RE: Response for Information Requested by DETSI

Capricorn Copper Pty Ltd (**CCPL**) received an information request for an EA amendment application on 21 October 2025 (your reference 101/0008746; A-EA-AMD-100915844). A response to the items raised on behalf of CCPL is provided below and summarised in **Appendix 01**.

Figure 1 TSF3 Project Area (black outline) with Disturbance Footprint (blue)

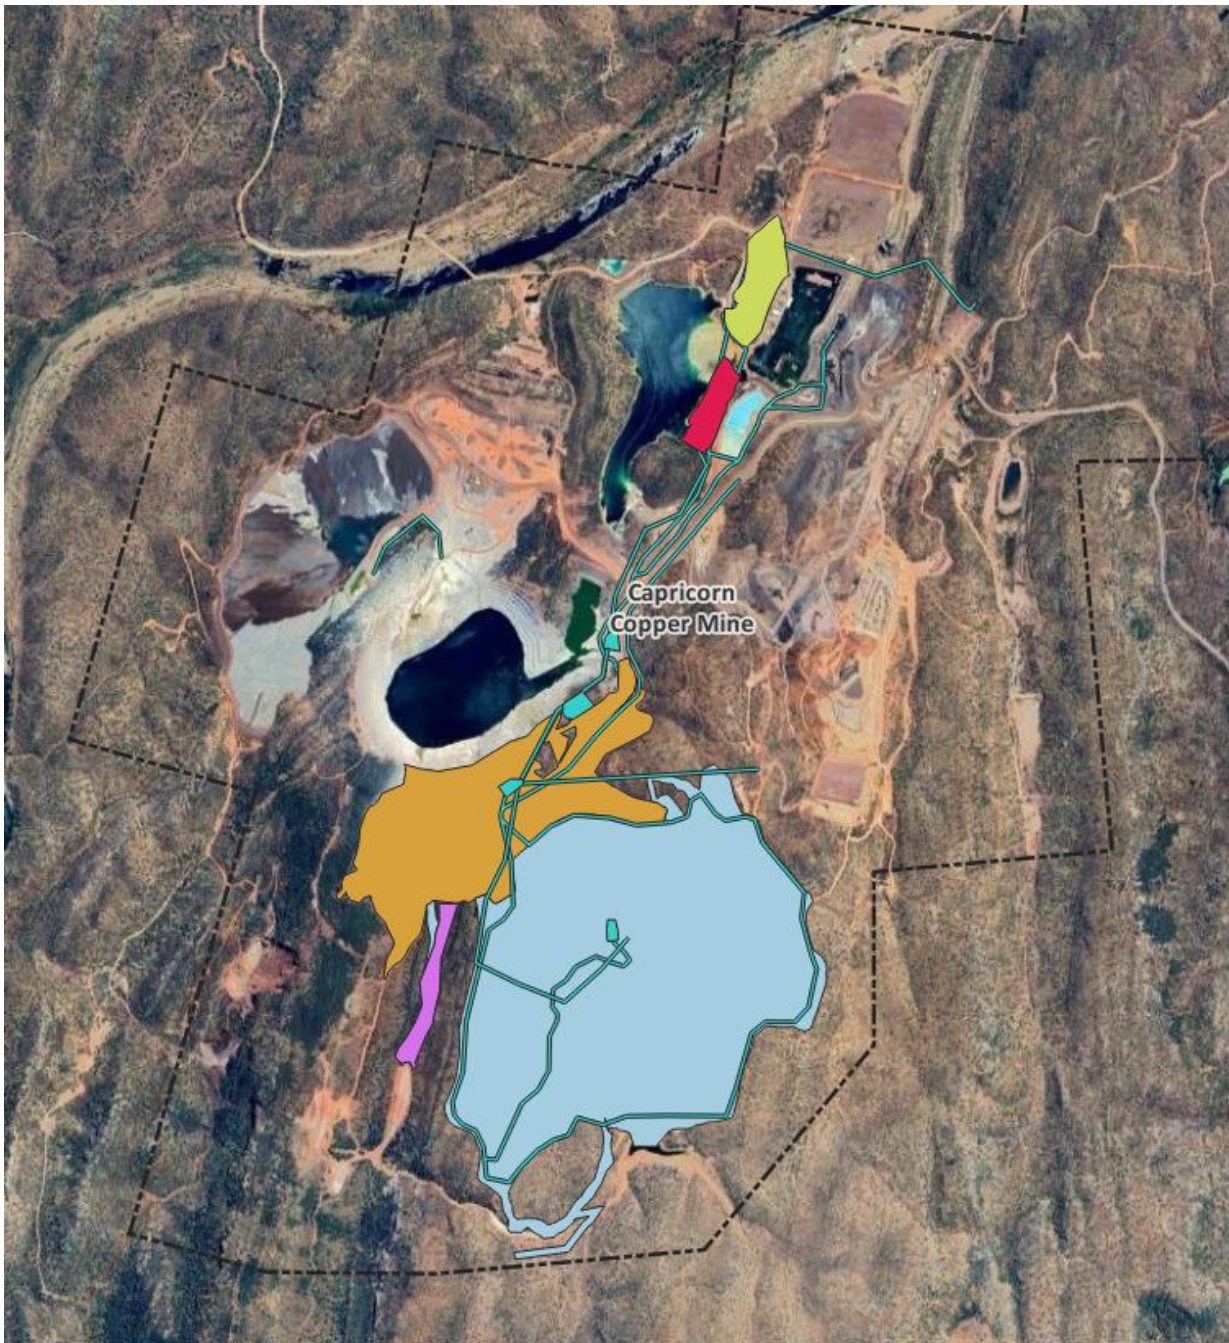
The application material (RPS 2025)¹ lacks a clear understanding of the proposed amendments to environmental authority EPML00911413 (the EA), including the intention and specifics, locations and proposed disturbance footprints.

- a. Itemises and includes a description of each proposed amendment.
- b. Provides a description of the location, including maps, GPS co-ordinates and total disturbance area in hectares (ha). Information should be provided in the same format as Schedule A-Table 1 (Authorised disturbance) of the EA.

The proposed amendment is for Tailings Storage Facility (TSF) 3 which will store fine metalliferous tailings, lime sludge (from proposed water treatment plant) and decant pond (water) on top of a tailings beach. TSF3 is proposed to be located in the Upper Esperanza Valley between Esperanza Waste Rock Dump (EWRD) and the Upper Esperanza Diversion Dam (UEDD) and is properly described as Lot 5 on Plan CP865892, which has Leasehold tenure (Calton Hills), refer to Figure 1 below.

There is a proposed disturbance footprint of 100.5 hectares which includes embankments, impoundment, topsoil stockpile and other disturbances within the ring road, the southern borrow pit, and restart infrastructure (powerlines, pipelines, pumps etc). The total tailings storage capacity of the current design is
